**FINAL SUPPLEMENTAL  
ENVIRONMENTAL IMPACT REPORT**

**CEDARS-SINAI MEDICAL CENTER  
WEST TOWER PROJECT  
ENV 2008-0620-EIR  
SCH # 2008031040**

**PROJECT NAME:** Cedars-Sinai Medical Center West Tower Project

FIGURE 46-A

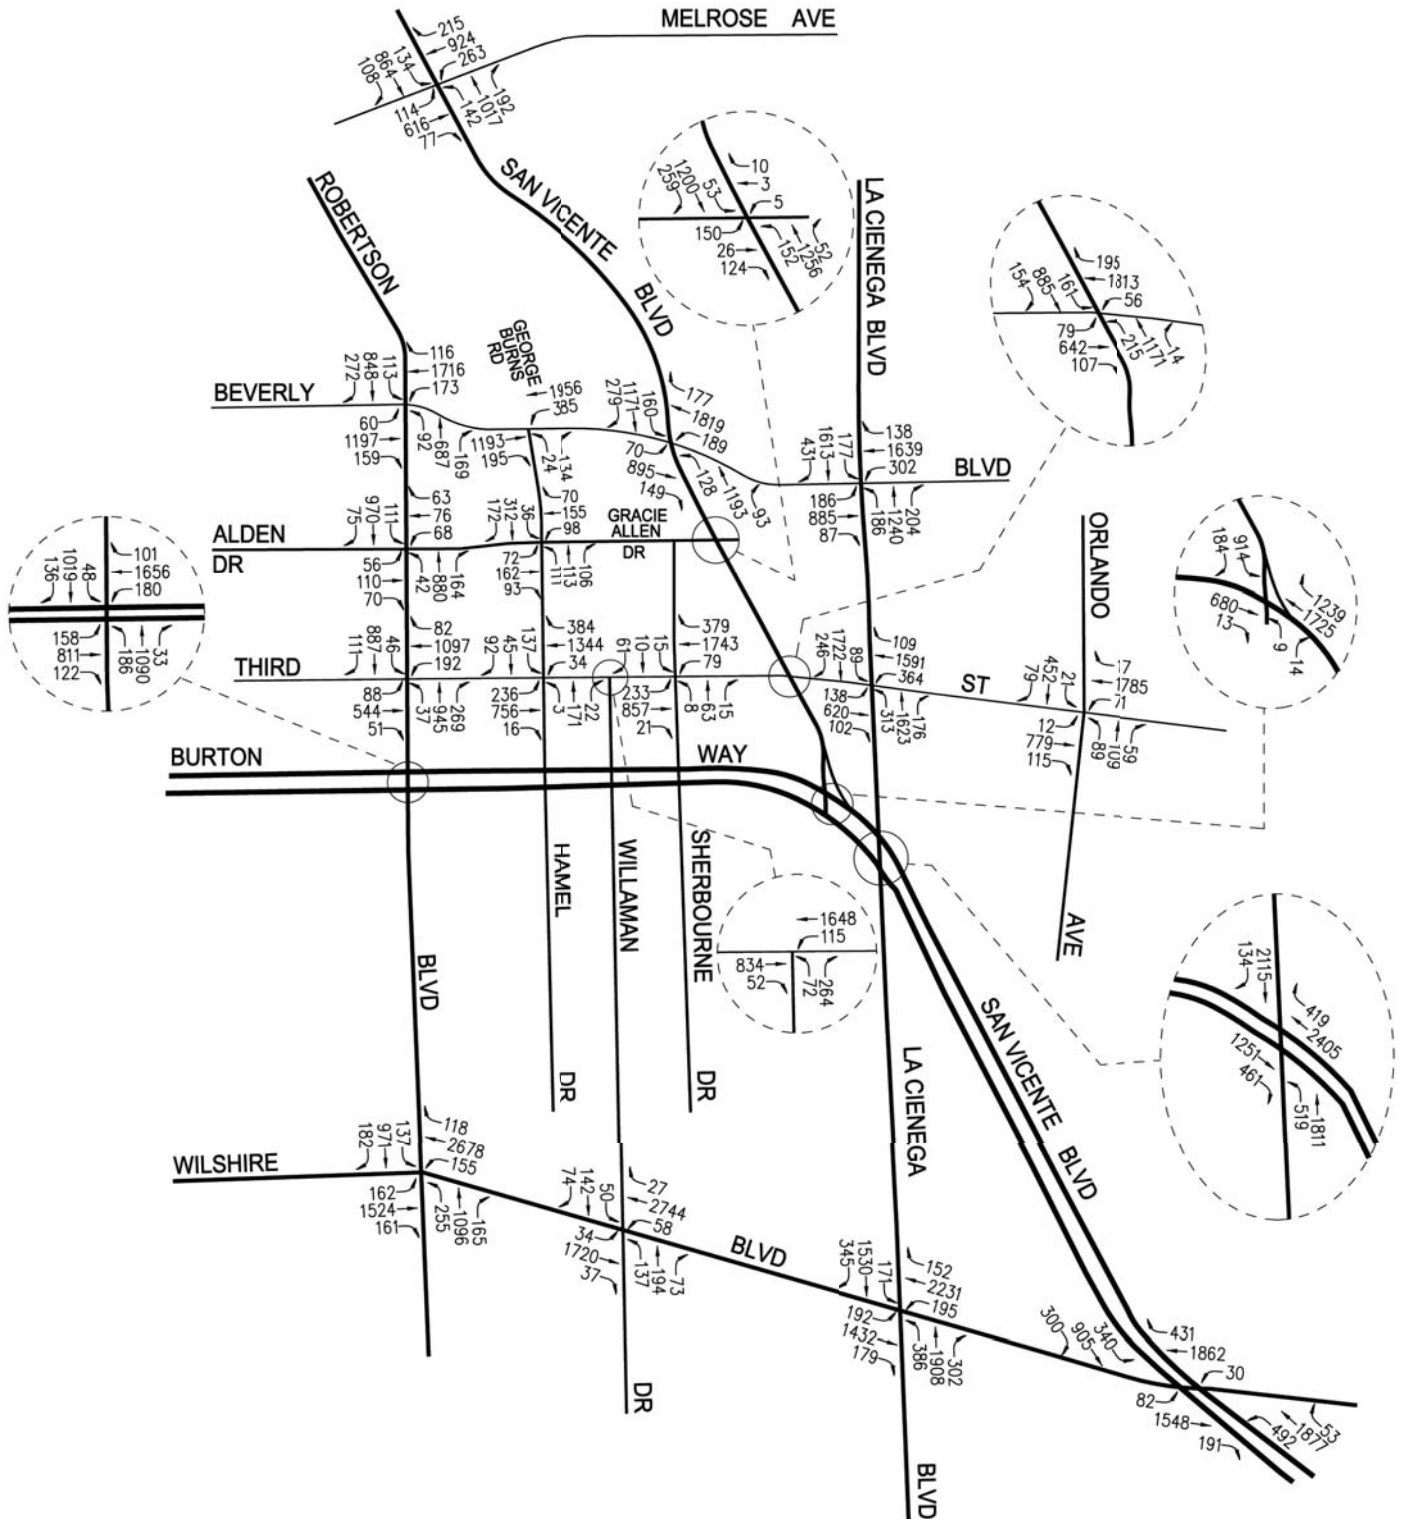
This comment refers to the inclusion of traffic volume figures for the “Project Only” and “Future With Project” scenarios in the Draft SEIR. The figures for peak hour traffic volumes for the “Project Only” were provided in the Draft SEIR (see pages 188 and 189 for *Figure 38, A.M. Peak Hour Project Traffic Volumes* and *Figure 39, P.M. Peak Hour Project Traffic Volumes*). The “Future With Project” figures were included in the Traffic Impact Study provided as *Appendix E: Traffic Impact Study* to the Draft SEIR (Figures 9-5 and 9-6 for the A.M. and P.M. peak hours, respectively). These figures have been added to this Final SEIR for clarification (see Correction and Additions III.C.5 and III.C.6 of this Final SEIR).

6. Page 214, Insert *Figure 46-A: Future with Project Traffic Volumes for A.M. Peak Hour* and *Figure 46-B: Future with Project Traffic Volumes for P.M. Peak Hour* after page 214 as pages 214-A and 214-B.
